# Access Compliance Report

## Public Rights-of-Way

### (Curb Ramps)

Intersection ID: 10034320	Main Street: PERIMETER_PY	Cross Street: N/A	Location:	SE
ADA ID: 5426AE1CCB24	Ramp Type: Perp	Initial Pass/Fail: Fail	Overall Compliance: No	Severity Score: 10
Codes/Mitigation Info/Possible Solution		Field Measurements/Component Compliance

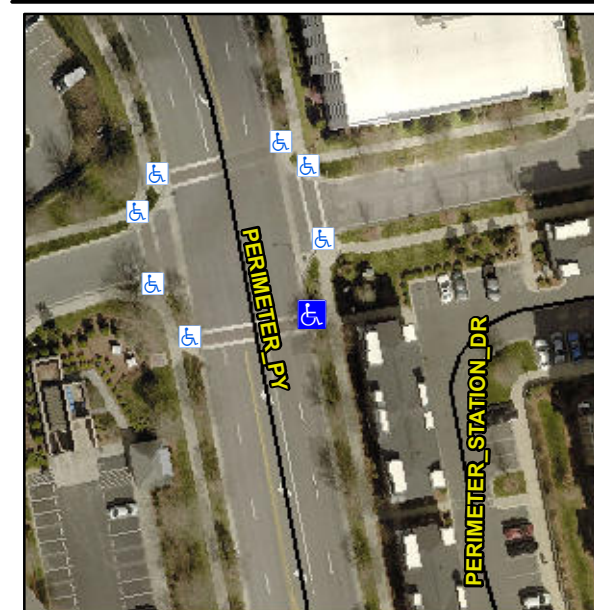
**Not Found, R304.5.1, R304.5.3**

Compliance	Description	Data	Compliance	Description	Data
N/A	Ramp Length (in)	96.0	Yes	Ramp Slope (%)	8.2
No	Ramp Width (in)	47.0	No	Ramp XSlope (%)	3.6
N/A	Flare Type LT	N/A	N/A	Flare Type RT	N/A
N/A	Flare Slope LT (%)	N/A	N/A	Flare Slope RT (%)	N/A
N/A	Flare Traversable LT?	N/A	N/A	Flare Traversable RT?	N/A
N/A	Landing Length (in)	N/A	N/A	DWS Provided?	N/A
N/A	Landing Width (in)	N/A	N/A	DWS Contrast?	N/A
N/A	Landing Slope (%)	N/A	N/A	DWS Length (in)	N/A
N/A	Landing X Slope (%)	N/A	N/A	DWS Full Width?	N/A
N/A	Landing Curb? (Y/N)	N/A	N/A	DWS Offset (in)	N/A
N/A	Shared Landing?	N/A			
N/A	Gutter Ponding?	N/A	N/A	Gutter Slope (%)	N/A
N/A	Gutter Lip Ht (in)	N/A	N/A	Gutter X Slope (%)	N/A
N/A	Painted X Walk1?	Yes	N/A	Painted X Walk2?	N/A
	X Walk 1 Direction	To W		X Walk 2 Direction	N/A
N/A	X Walk 1 Width (in)	72.0	N/A	X Walk 2 Width (in)	N/A
	X Walk 1 Slope (%)	1.3		X Walk 2 Slope (%)	N/A
	X Walk 1 X Slope (%)	3.4		X Walk 2 X Slope (%)	N/A

**Remove & Replace Entire Ramp.**
